OGN-SMD and OGN product family combined.

Product Change Notification					PCN OGN family consolidation		
owner	creation date	release date	released by	change order no	rev	page	D10-063-657
sariogar	03.03.2022	14.04.2022	schulejo	2023609	A	1 of 4

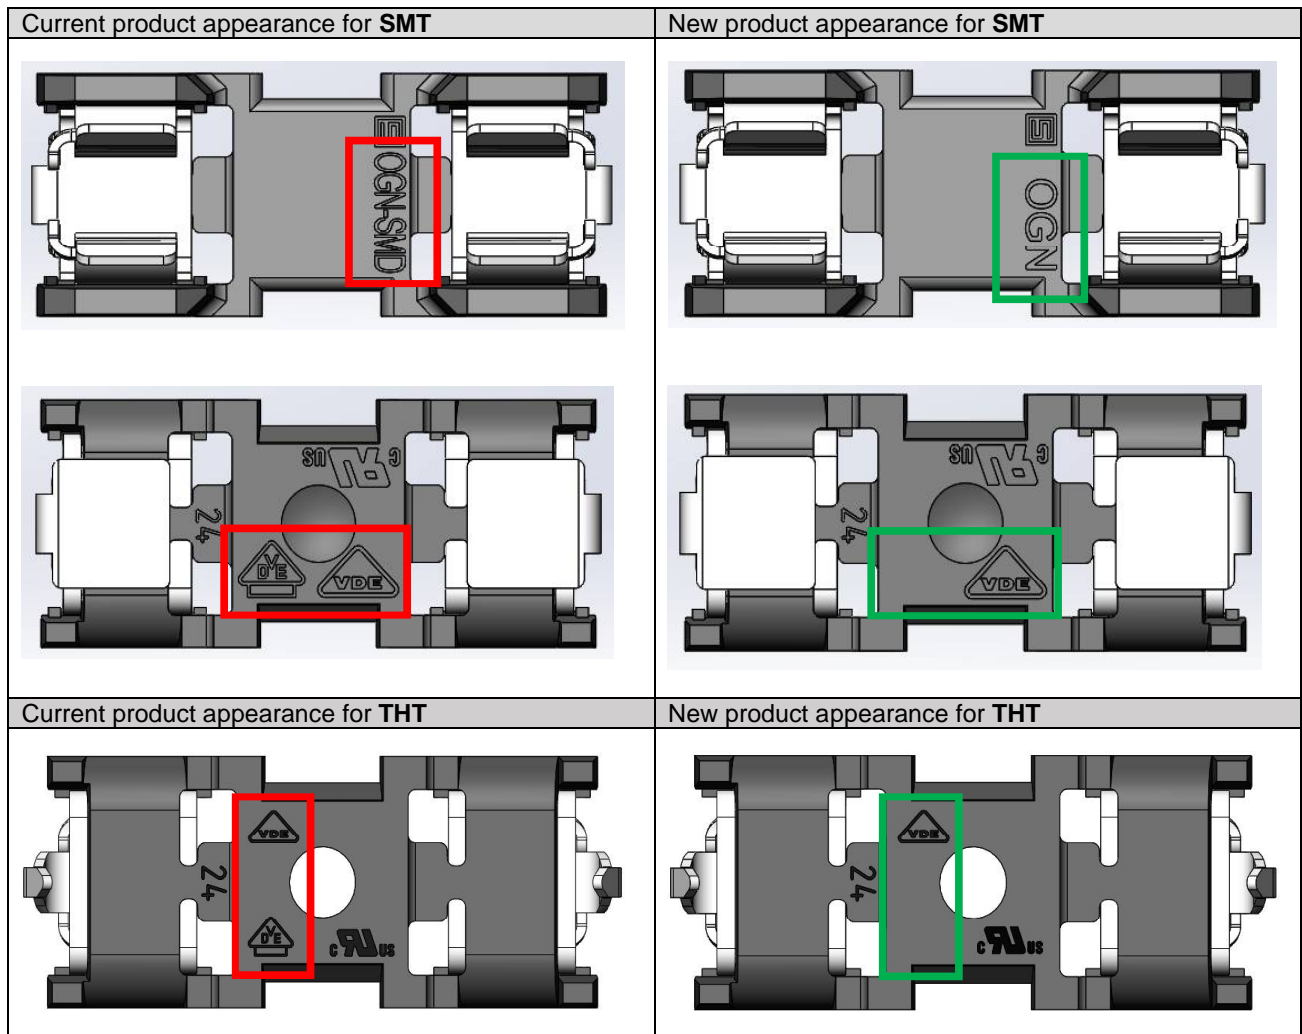
Current label for SMT	New label for SMT
Current label for THT	New label for THT
Current product rating	New product rating
UL 500V / 16A VDE 250 VAC / 4W / 10A VDE ÜG 500 VAC / 4W / 16A	UL 500V / 16A VDE 250 VAC / 4W / 10A VDE 500 VAC / 4W / 16A
Current configuration code	New configuration code
OGN-140-11-0 OGNSMD-250-11-0	OGN-140-11-0 (OGN for THT) OGN-250-11-0 (OGN for SMT) All standard OGN-SMD parts will have the configuration code changed by removing "SMD". The first number of the configuration code indicates the mounting method.

- Form No action required, no change of dimensions
- Fit
- Function
- Manufacturing
- Label Verify your approval documents to use VDE ÜG file number 40045404
- Packaging
